STATUTORY PLANNING OFFICERS REPORT

Urban Planning Delegated Committee

Application No.	PP21/0271
Date Application Received	9 April 2021 (application amended pursuant to Section 50(3) on 8 June 2021, before public notice)
Planning Officer	Seuna Byrne - Principal Planner
Applicant	VMCH C/- Human Habitats
Owner	VMCH
Property Address	6 and 14 Studley Park Road, Kew
Proposal	Use of the land for not more than 108 retirement village apartments and a food and drink premises (café); construction of four x 5-storey buildings above basement car parking, including a fence as the fence is visible from a street and externally painting a building (Whitty House); partial demolition of buildings; reduction of the car parking requirement associated with a café; and alteration of access to a road in a Road Zone, Category 1 (Studley Park Road)
Ward	Studley
Zoning	<ul style="list-style-type: none"> • 6 Studley Park Rd - NRZ3 • 14 Studley Park Rd - GRZ4 • Adjacent to a road in a Road Zone, Category 1

Above: Figure 6: The ground floor plan annotated with suggestions for improvement

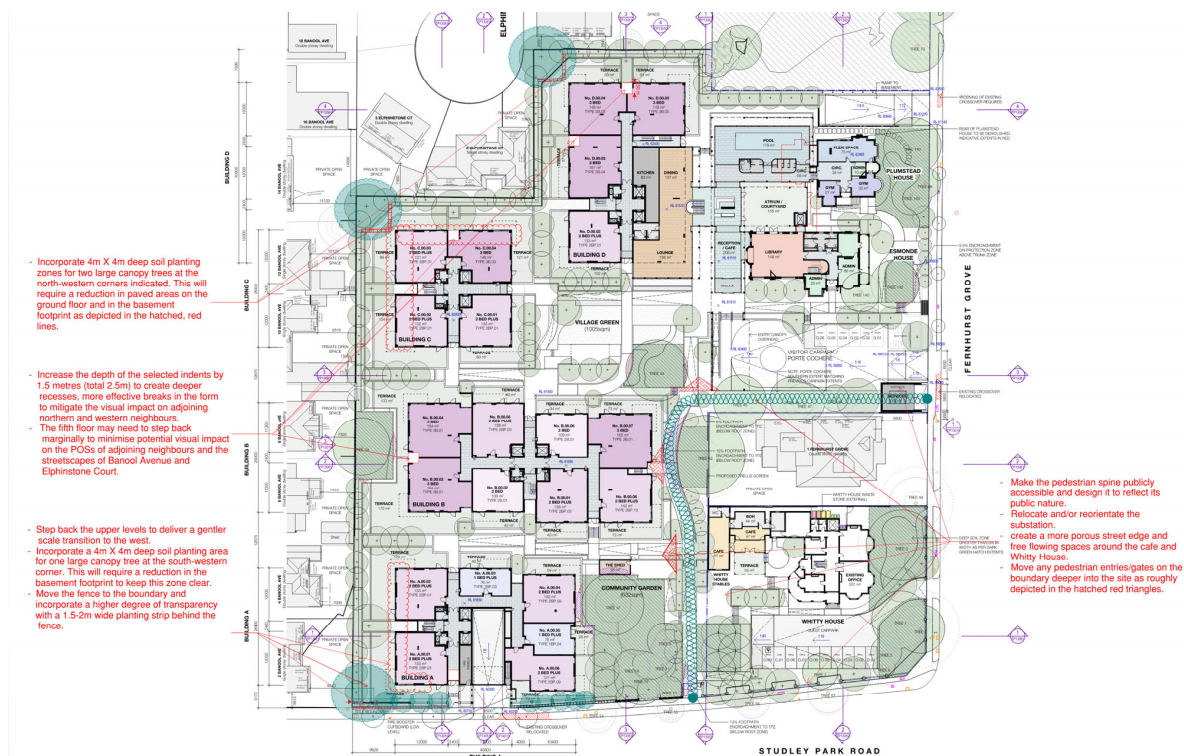
A dedicated 4m x 4m deep-soil planting zone at the southwestern corner, extending down to the basement level, may also be needed to further soften this interface. Refer to the annotations on the ground floor plan in Figure 6 below and the elevational diagrams on the following pages.

As denoted on the extracted ground floor plan diagram in Figure 6, a few relatively minor modifications in the northern and western elevations should help temper the visual mass in the views from adjacent properties and address any adverse impacts. These could potentially include, but not limited to, deeper and more profound rebates in specific locations such as the northern and western walls of Building D, the northern wall of Building C, and the western elevation of Building B.

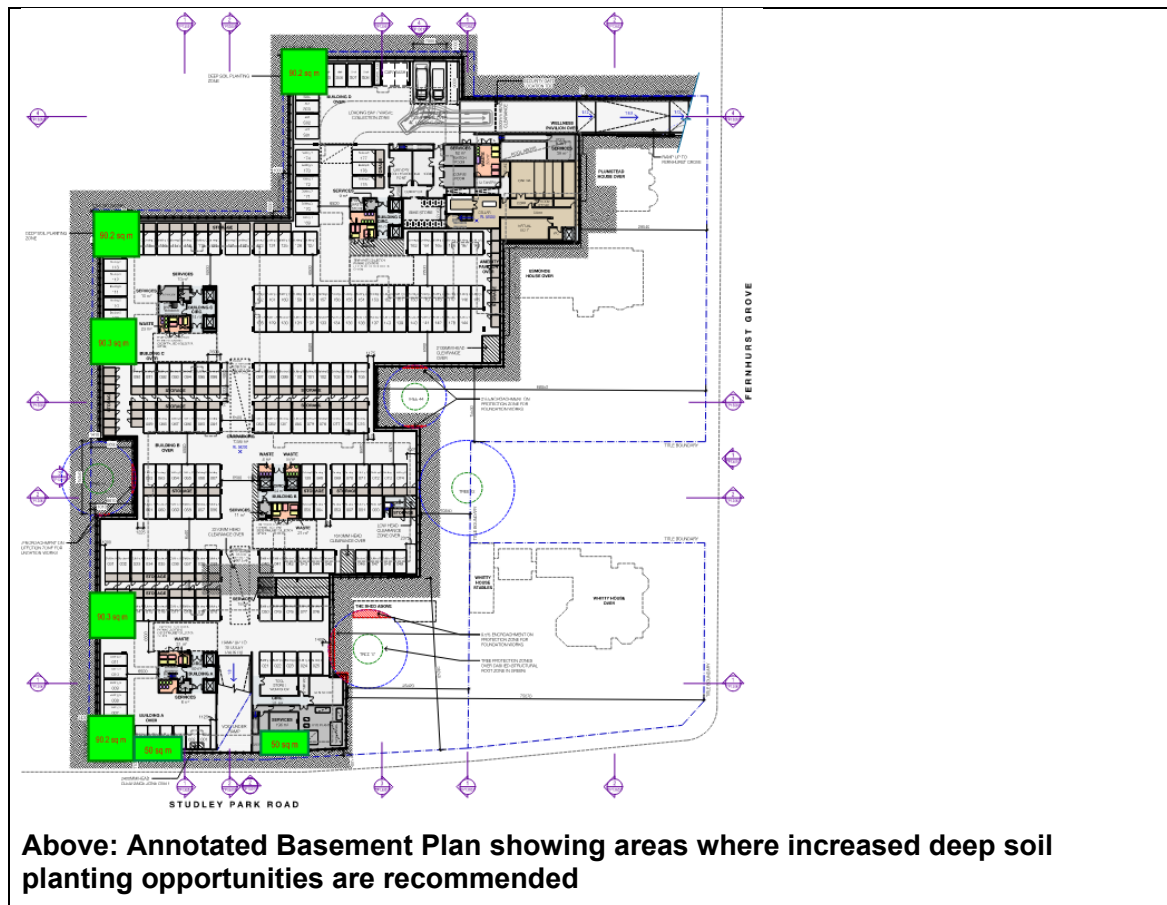
- A. Increase the amount of sufficient permeable deep soil to accommodate medium canopy (8-12m in height) trees across the Studley Park Road frontage that will contribute to neighbourhood character**

- B. The landscaping outcome (specifically inclusion of large canopy trees) across the western property boundary is considered insufficient and should provide for sufficient permeable deep soil to accommodate canopy trees**

I have annotated the basement plan with suggested locations of deep soil areas to satisfy recommendation A and B, below.

- Retaining Tree No. 49;
- Providing 4m x 4m deep soil planting zones in the south-west and both north-west corners of the site;
- Increasing the width of the deep soil planting zone in front of Building A, from 1.1m to between 1.5m - 2.0m;

Above: (L) The advertised substation arrangement and (R) the modified substation arrangement the applicant would accept via permit conditions

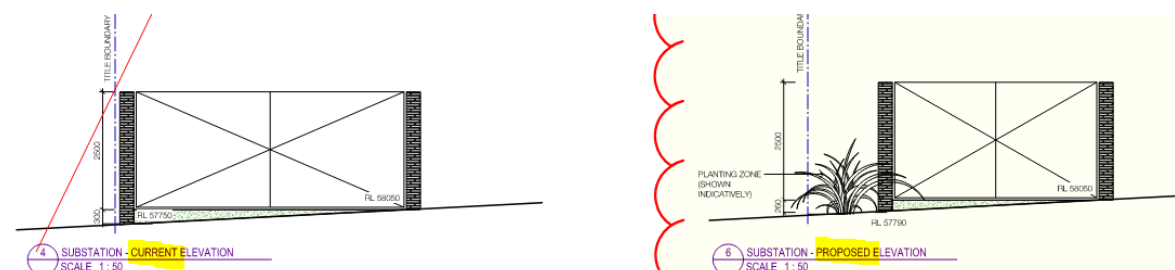
- The addition of three 4m x 4m deep soil planting cut-outs in the basement along the western and north-western boundary;
- Reduction in the size of the substation and adjustment to its location to enable the retention of Tree 49 (Weeping Lilly Pilly) and to provide a landscape buffer between the facility and the common boundary with No. 1 Fernhurst Grove;

Above: Architects' 3D render of a modified Building A if Levels 3 and 4 are amended in accordance with the recommendations of Council's Urban Designer. The applicant has indicated they will accept permit conditions to this effect

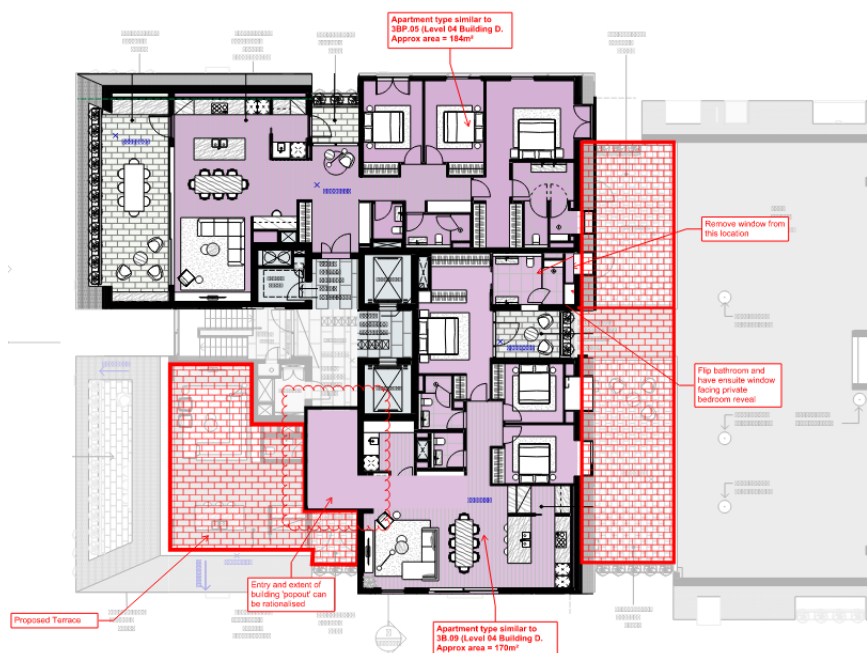
- Modifications to Levels 3 and 4 of Building A, to provide an improved transition in scale to the western adjacent dwelling at No. 2 Banool Avenue, in accordance with the recommendations of Council's Urban Designer;
- Activation of the Whitty House forecourt area through programming that supports community engagement and participation, via the preparation of a Community Development Plan (CDP). The CDP would provide for activation of the space, which may include:
 - Partnerships with community groups and schools to participate in management of the community garden;
 - Workshops held in collaboration with Council to provide education on topics such as gardening, growing vegetables and composting; and
 - Farmer's markets and events.

The design alterations suggested in the sketch plans are encouraging and positive. In particular, we note the considerable erosion of mass and the stepped profile at the south western corner. The applicant is commended for adopting the most conservative option suggested in our advice, as may be appreciated from the 3D views submitted below. This will dramatically alter Building A, improve its presence within Studley Park Road and deliver a gentler and more considerate scale transition to the adjoining western neighbour No. 2 Banool Avenue.

Above: The areas of Building C and D, Level 3, required to be modified to achieve Standard B17 compliance, due to its siting adjacent to the SPOS of No. 2 Elphinstone Ct (the northern boundary setback to Apartment C.03.03 already complies with B17)

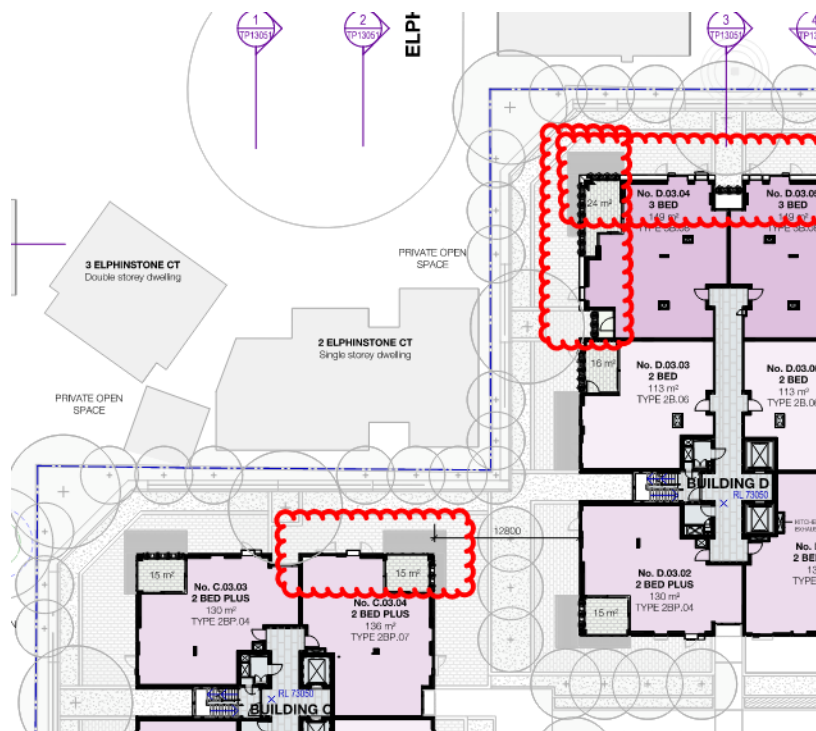
The recommended permit conditions achieve compliance with Standard B17 for those parts of Building C sited adjacent to the SPOS of No. 2 Elphinstone Court (i.e. generally opposite its centrally located southern courtyard and adjacent to its northern yard). This targets the highlighted areas of Buildings C and D, as marked, below.

Above: Annotated extract of the Level 4 floor plan of Building C, highlighting that part of the building required to be modified to achieve compliance with Standard B17

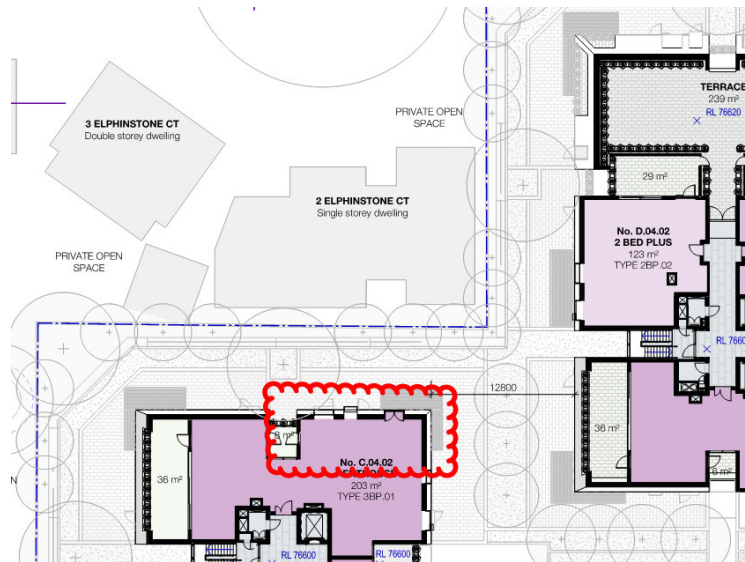
For Level 4 of Building C, officers recommend the north-east quadrant be amended to achieve compliance with Standard B17 (as depicted, below). Modifications to the north-west quadrant are not recommended, as that part of the building is not sited opposite the southern courtyard of No. 2 Elphinstone Court.

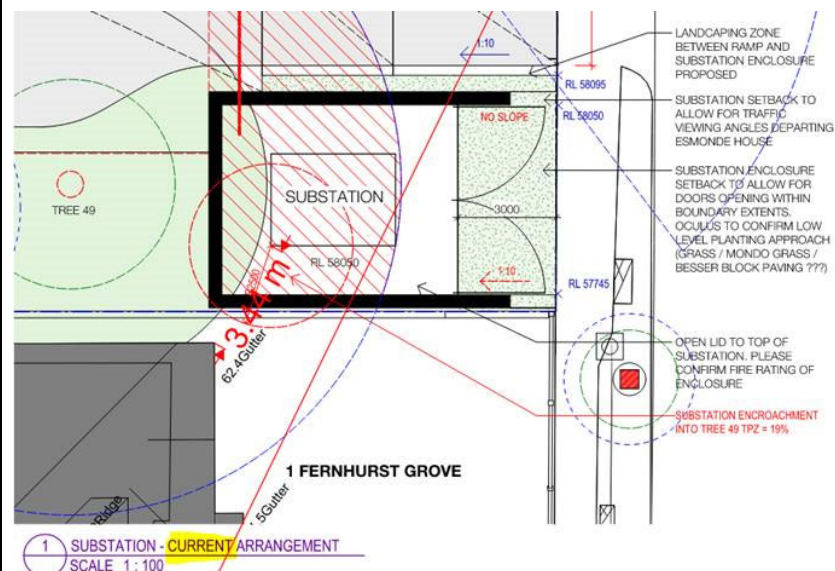
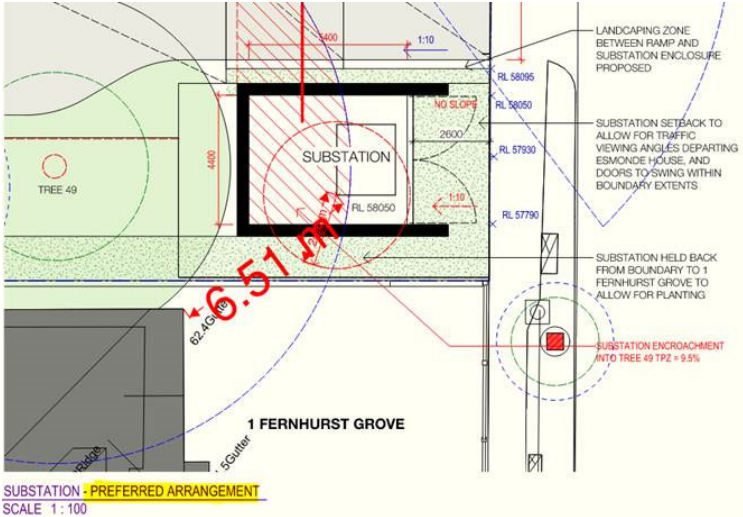
1 Fernhurst Gve.
Why was the
substation at Kew
Recreation Facility
required to be 5m
from the
neighbouring
dwelling?

Sketches of the advertised and revised arrangements (as a result of the recommended permit conditions) are provided below.
